<p><b>CITY OF CALGARY</b>  <b>RECEIVED</b>          IN COUNCIL CHAMBER</p> <p><b>JAN 12 2015</b></p> <p>ITEM: <u>CPC2015-007</u>  <u>Distribution</u></p> <p>CITY CLERK'S DEPARTMENT</p>
--

The proposed development at 3404 Richmond Road S.W. barely meets 50% of the proposed location criteria for multi-residential infill

**Figure 4. Primary Transit Network**

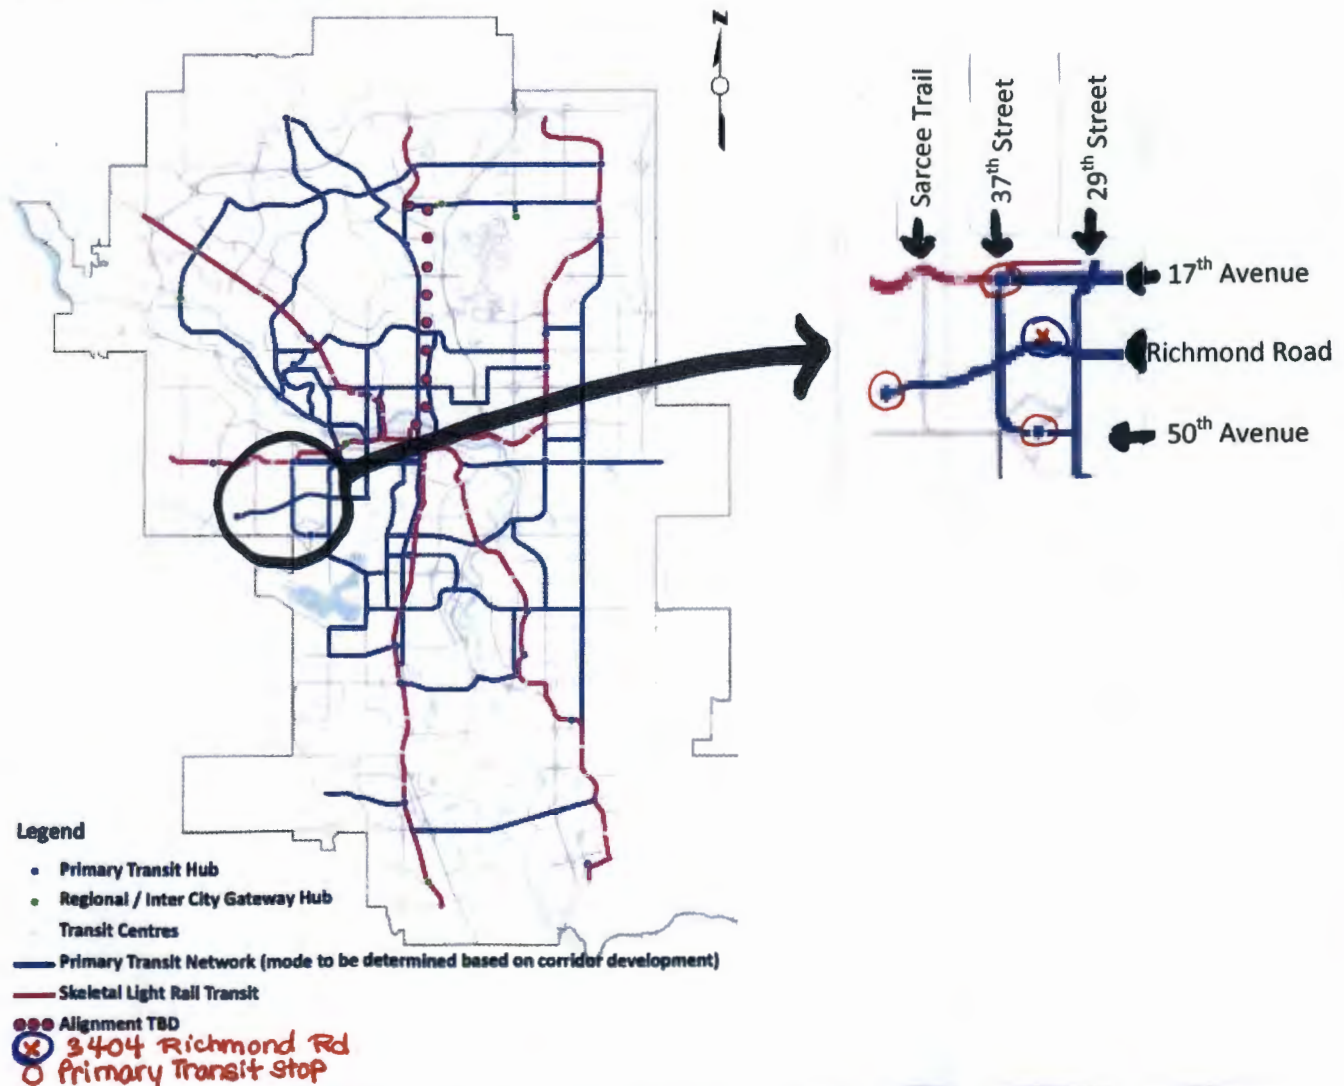
THE NEAREST EXISTING OR PLANNED PRIMARY TRANSIT STOPS ARE AT LEAST THREE TIMES GREATER THAN THE 600 METER GUIDELINE (THEY ARE 1.8 AND 2.2 KM AWAY WITH ONE PLANNED WEST OF SARCEE TRAIL ACCORDING TO THE "TRANSITWAYS AND THE ROUTEAHEAD FOR CALGARY TRANSIT" POSITION PAPER OF 2013 PAGE 6)
